AMENDMENTS TO THE DRAWINGS

Appl. No. 10/575,365
Docket No. Q78082
Amdt. Dated February 29, 2008
Reply to Office action of November 29, 2007
Annotated Sheets Showing Changes

Fig.1

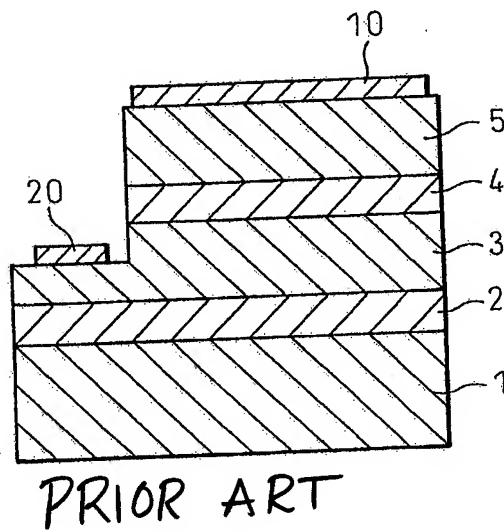
In response to the drawing objection, a replacement sheet is submitted herewith so as to label Figure 1 as --Prior Art--, and to change the drawing sheet pagination from "1/1" to "1/2". In addition, a new drawing sheet (Figure 3) is submitted herewith to show the feature of "a light-emitting diode comprising a flip-chip-type gallium nitride compound semiconductor light-emitting device".

In response to the drawing objection, a replacement sheet is submitted herewith so as to label Figure 1 as --Prior Art--.
